ALERT SERVICE BULLETIN

NO. 214ST-97-78

MODELS AFFECTED: 214ST

SUBJECT: SELF-LOCKING BARREL NUT,
P/N NAS577B-10A ONE TIME INSPECTION.

FIGURE 1
NAS577B-10A BARREL NUT LOCATIONS

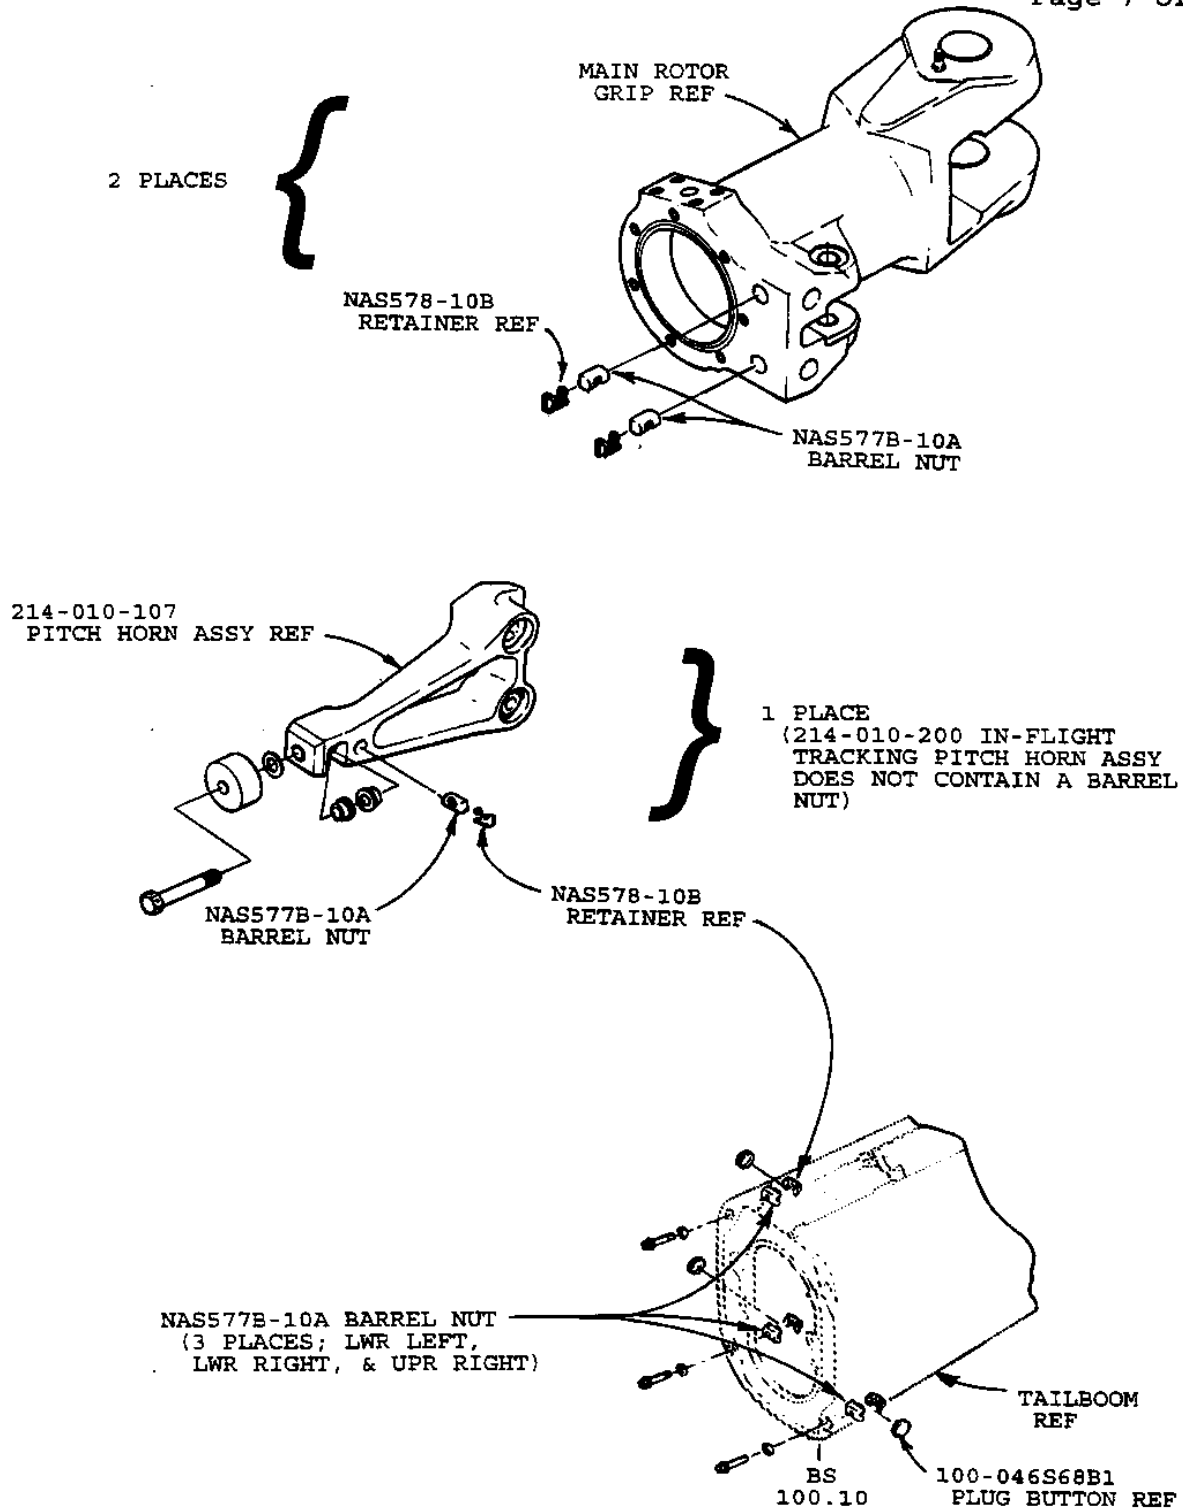
1. Gain access to the component/assembly/barrel nut being inspected. Refer to Figure 1 for P/N NAS577B-10A applications. The following inspections also apply to all P/N NAS577B-10A barrel nuts which may be on hand as individual spares.

THE PART NUMBER AND MANUFACTURER'S CODE ARE LOCATED TOGETHER ONLY ON ONE END OF THE BARREL NUT. THEY MAY ALSO BE OBSCURED BY A PORTION OF THE RETAINER. FOR INSTALLED ASSEMBLIES IT MAY BE NECESSARY TO REMOVE THE BARREL NUT FOR PROPER IDENTIFICATION.

FIGURE 2
NAS577B-10A BARREL NUT
(NAS578 RETAINER NOT SHOWN)

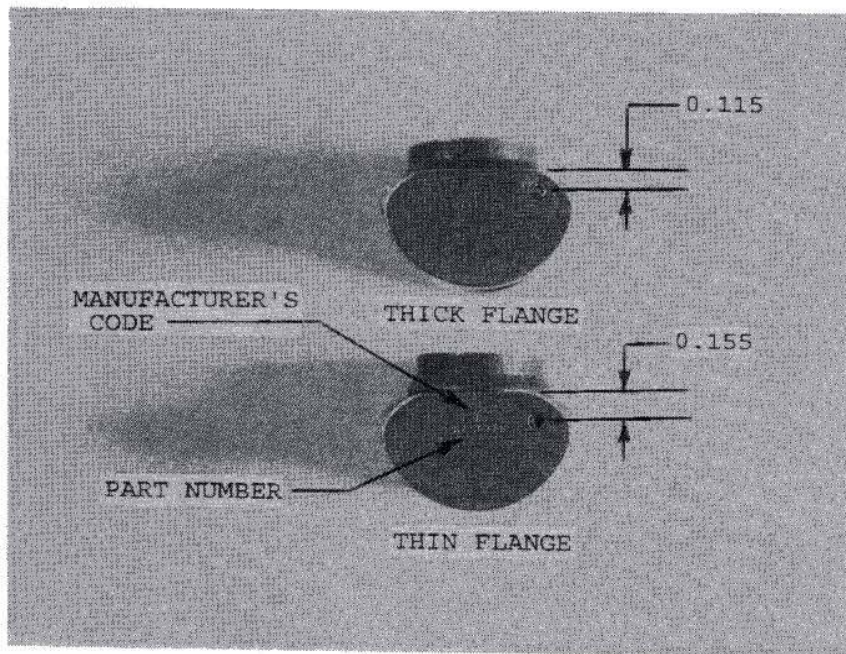
- a. Viewing the end of the barrel nut, inspect the barrel for the presence of a manufacturer's mark. Kaynar nuts are identified by the presence of a "K", depressed above the basic part number, **NAS577B** (refer to Figure 2). For installed barrel nuts, if the part number or manufacturer's mark can not be seen; or are not legible, the barrel nut must be removed from the component (see caution note above). If any manufacturer's identifying mark is found other than "K", the barrel nut is considered serviceable and no further action is required.

- b. If the "K" marking is found, measure the distance from the center of the roll pin securing the nut in the barrel to the flat surface of the barrel (refer to Figure 2). If the edge distance is approximately .115 inch, the nut is considered serviceable, no further action is required. If the dimension is approximately .155 inch, remove the barrel nut from service and replace with a serviceable barrel nut.

Replace any barrel nut that can not be positively identified.
